# CHANGE ORDER

Project Name: **Haverhill Consentino Middle School** CO No. **16**

Architect's Project No. **21-0818**

See attached list of 5 item(s) for a total of ..... **\$43,036.66**

## JD-119

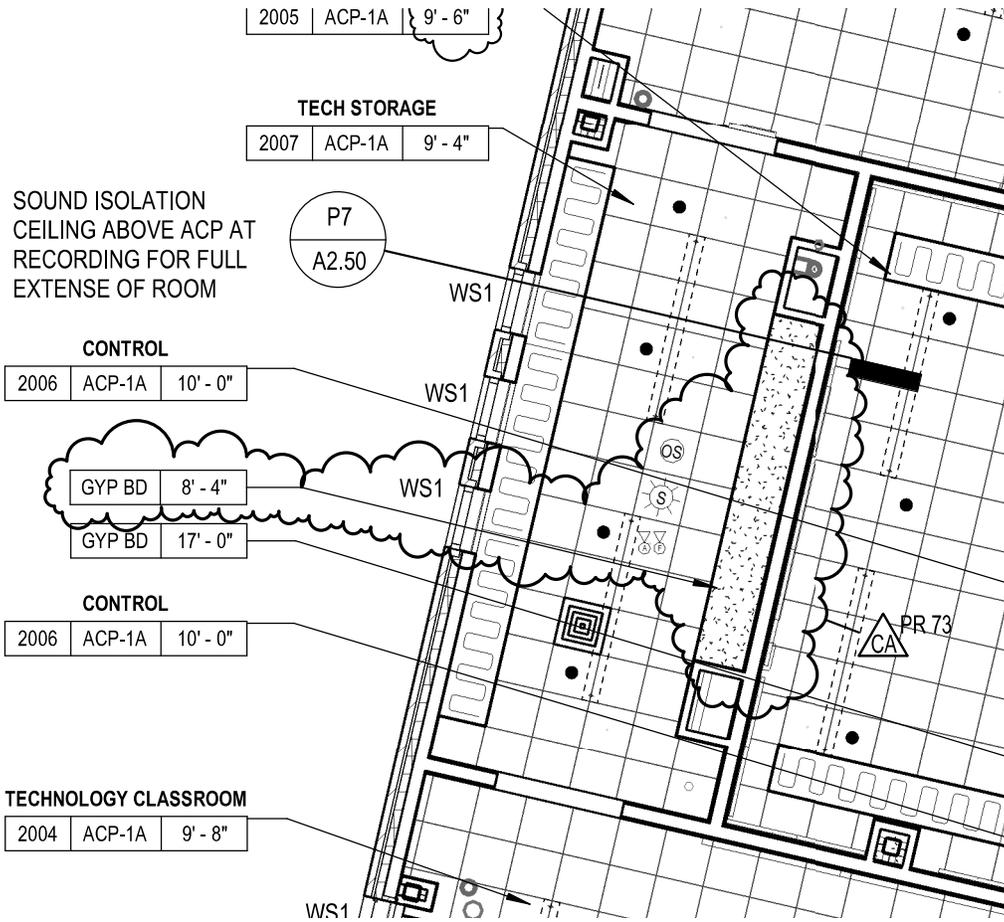
To coordinate with overflow rain leader coordination, make the following revisions:

Sheet A2.23, LEVEL 2 REFLECTED CEILING PLAN - AREA C AND D, add new gypsum soffit as shown on the attached sketch **JD-119**.

SHEET NUMBER: C4.01

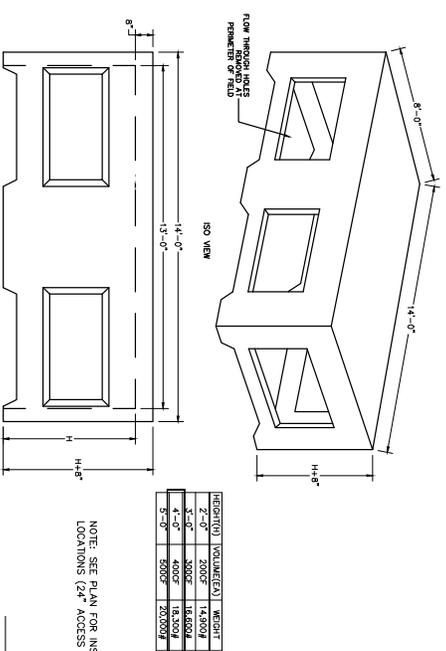
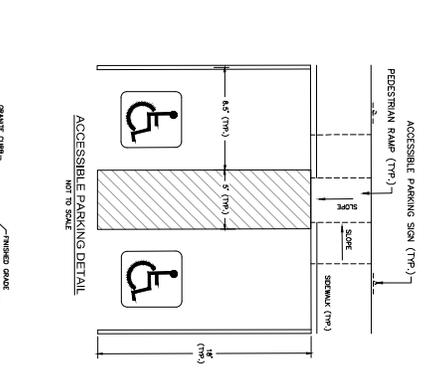
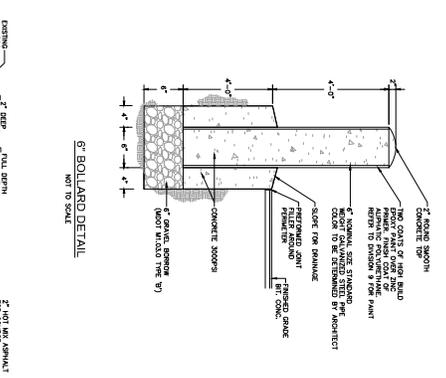
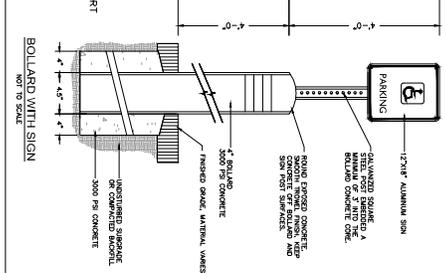
Contractor to provide geotextile – place a layer of non-woven geotextile between the approved soil subgrade and the dense graded aggregate to act as a separation layer between the subgrade soil and the aggregate base. Refer to attached specification **31 05 19 – Geotextiles**.

At Sheets C4.01 C4.02, C4.03, C4.04, LAYOUT PLANS, see limits of geotextile shown on attached.
